Coalescing Style Air Dryer

M-561-002

(February 2009)

ALL CXU, CHU, GU, TD, MRU, LEU

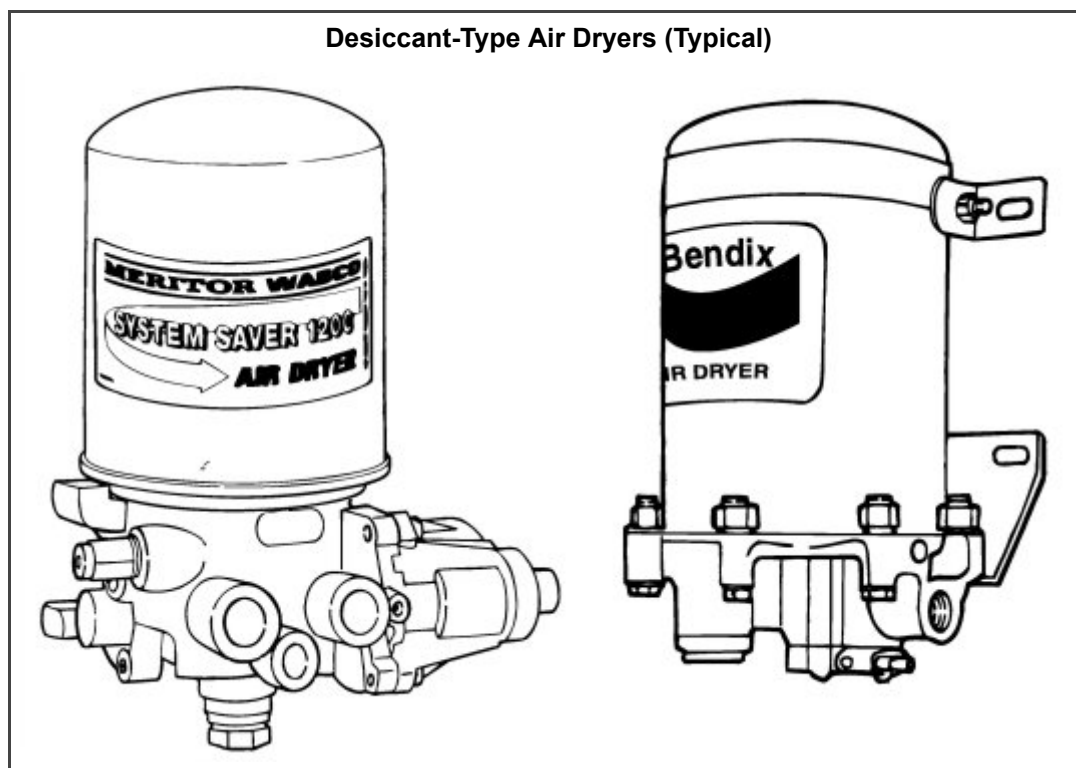
Effective mid-September 2008, all MACK chassis are equipped with air dryers which utilize an oil coalescing desiccant cartridge which removes atomized oil and other particulate matter from the air system. The oil coalescing desiccant cartridge must be changed yearly. Refer to the specific air dryer service literature for detailed information.

Note: It is strongly recommended that the cartridge be replaced on a yearly basis with a new coalescing-type filter cartridge.
